10 November 2020

## **Taumatotara Wind Farm – Noise effects of change in turbine**

## 2 Review by Marshall Day Acoustics

# Taumatatotara Windfarm

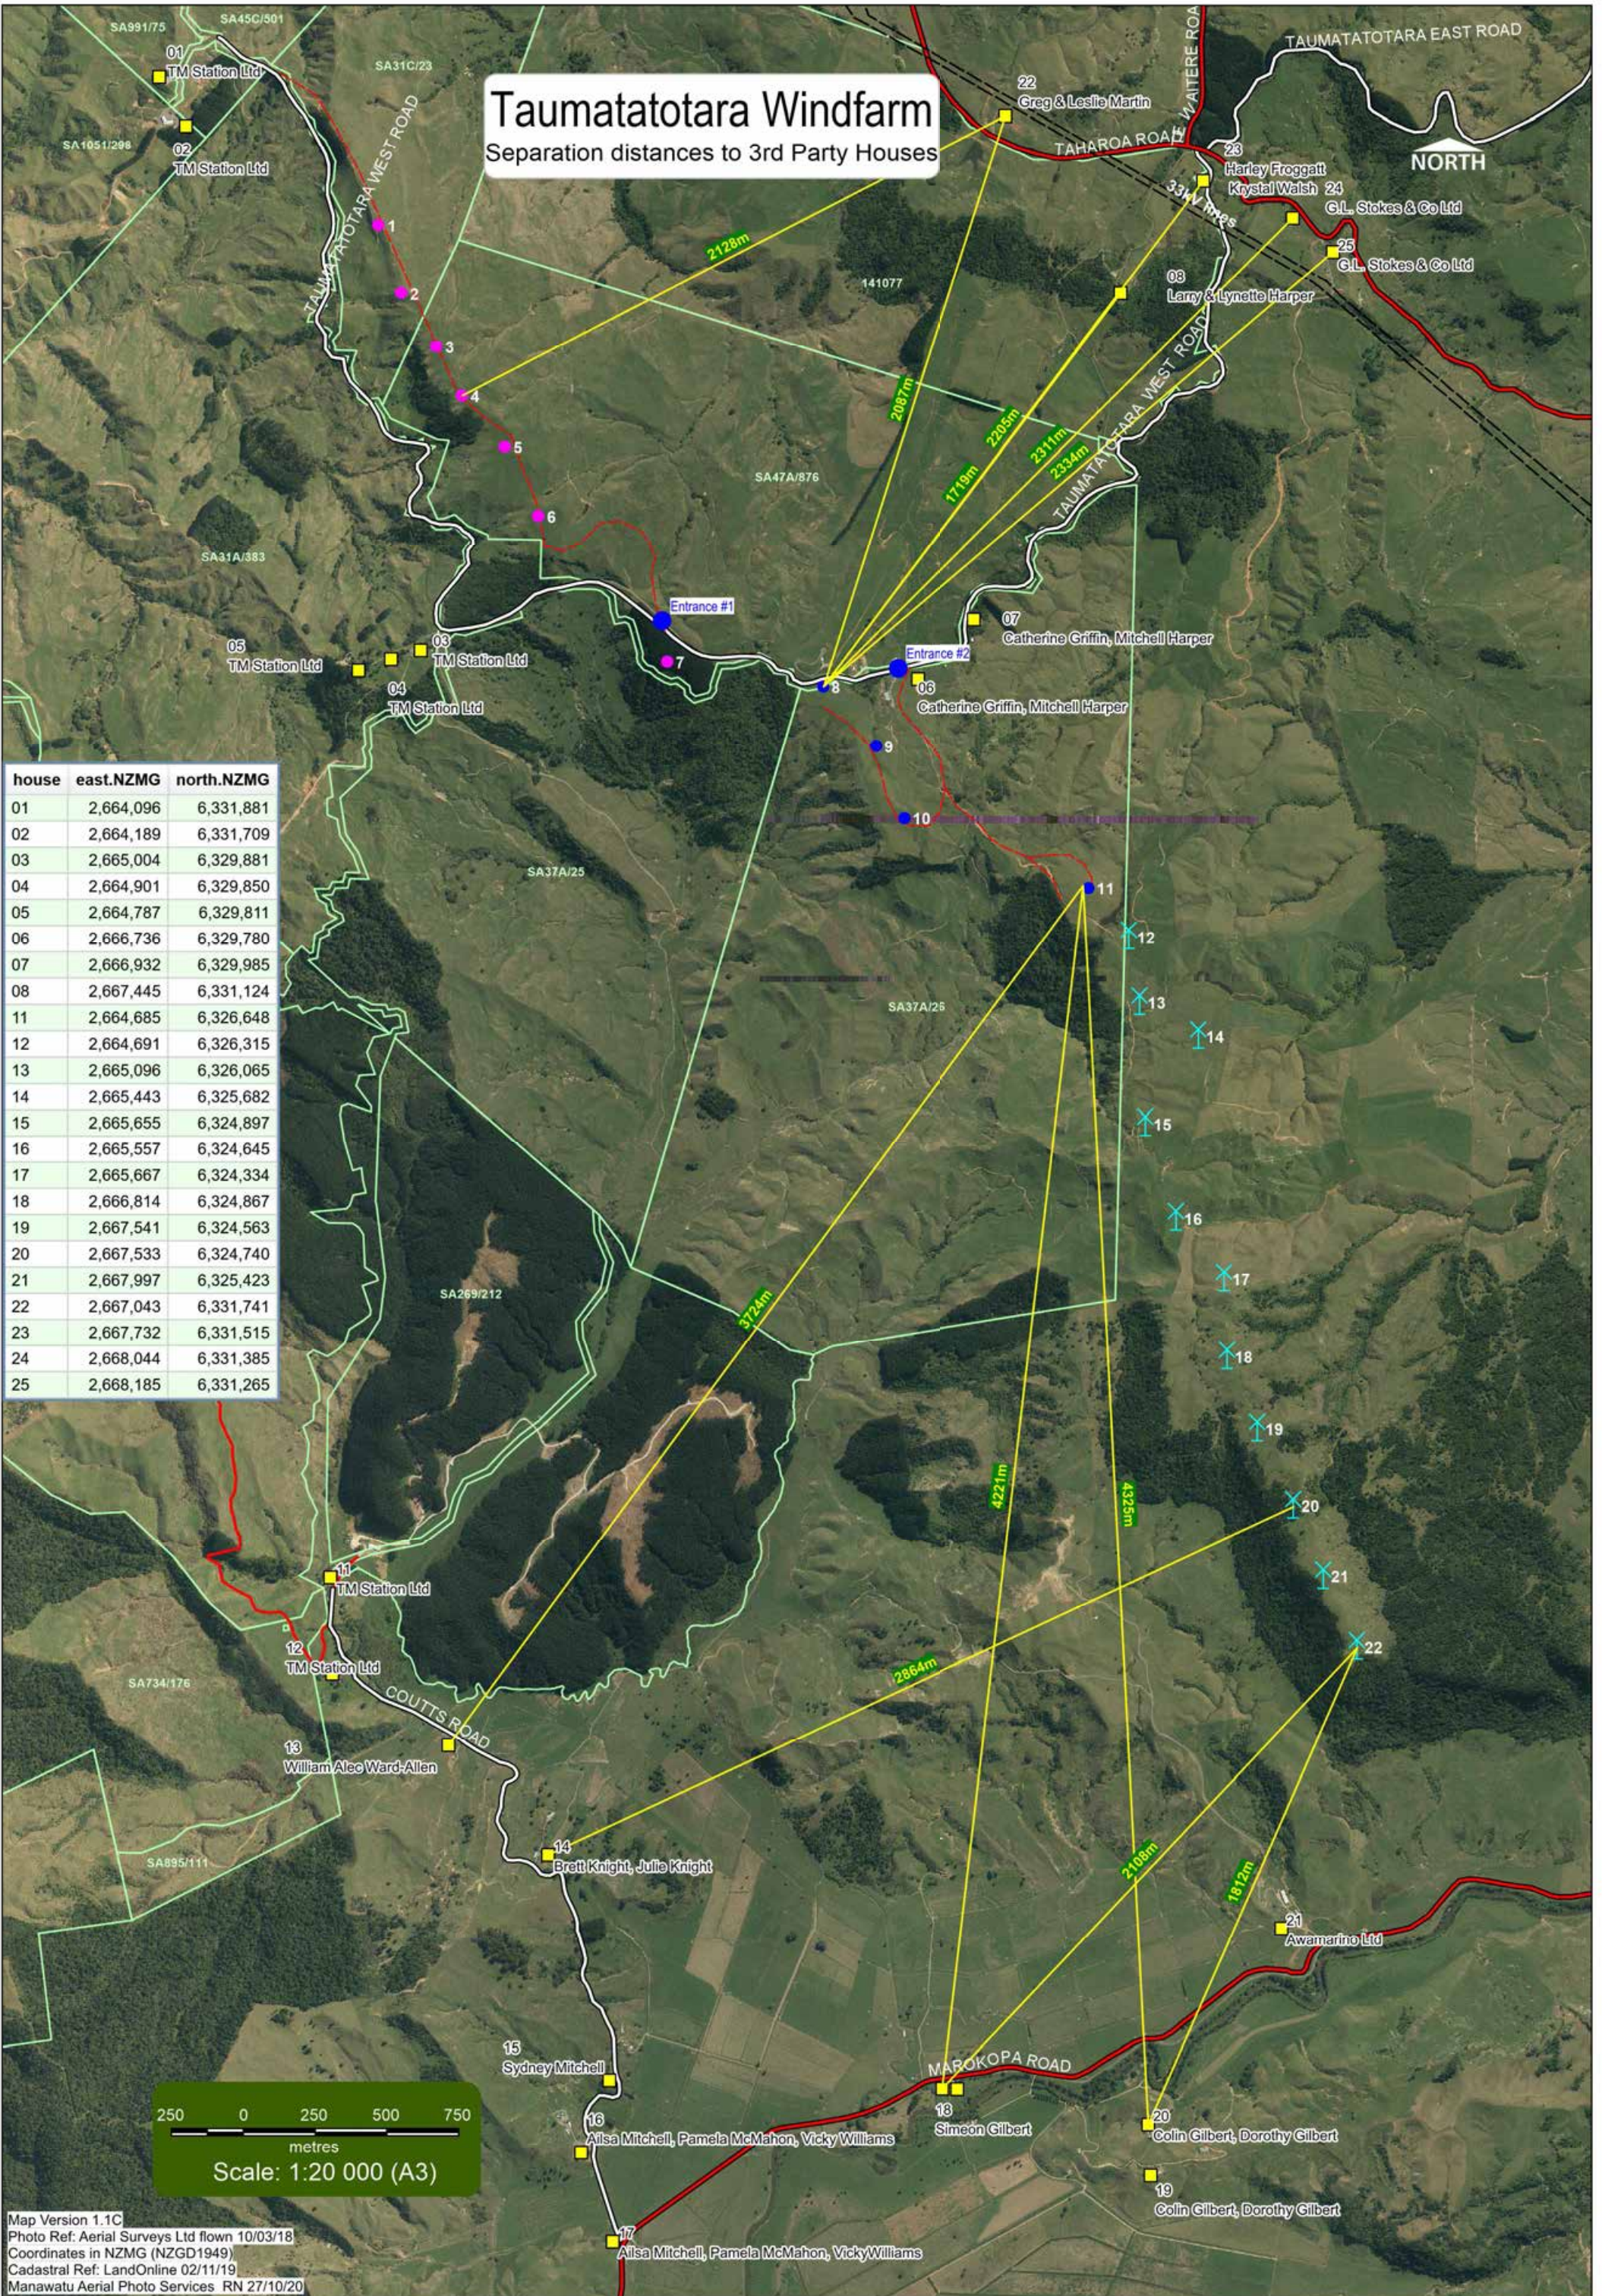
Item	Information requested	Response
3	At least one appropriately timed survey of sufficient duration should be undertaken to fulfil the requirements of NZS6808. This survey should be undertaken at one relevant receiver location following accurate predictions of noise levels at all relevant receivers (refer below). The receiver location should not be on the wind farm site. However, if a dwelling is outside the wind farm site but has provided written approval, this location may be a suitable measurement location.	<p>This request relates to issues with the original application.</p> <p>There is no proposal to alter the turbine locations, therefore no new receivers are affected.</p> <p><b>No additional information required</b></p>
4	The coordinates of all dwellings that are to be assessed (i.e. not on the wind farm site, or from which written approval has been obtained from the owner and occupier)	<p>Coordinates are included on the site plan v1.1c.</p> <p><b>We recommend that this plan is updated to clearly identify which positions noise limits apply to</b></p>

No	Operative condition	Suggested update
7	<p>The noise from all other activities on the site (other than wind turbine generator operation and construction activities) shall not exceed the following limits when measured in accordance with the requirements of NZS 6801:1991 Measurement of Sound and assessed in accordance with NZS 6802:1991 Assessment of Environmental Sound:</p> <p>7.00am to 7.00pm      45 dBA L<sub>10</sub>  7.00pm to 7.00pm      35 dBA L<sub>10</sub>     60 dBA L<sub>max</sub></p>	<p>The consent holder shall ensure that sound from sources on the site other than those within the scope of conditions 8 and 12 does not exceed the following noise limits:</p> <p>7.00am to 7.00pm    45 dB L<sub>Aeq(15min)</sub>  7.00pm to 7.00pm    35 dB L<sub>Aeq(15min)</sub>     60 dB L<sub>AFmax</sub></p> <p>Sound shall be measured in accordance with NZS 6801:2008 and assessed in accordance with NZS 6802:2008.</p> <p>The assessment positions shall be at the noise sensitive locations shown on Site Plan 1.1c attached.</p>
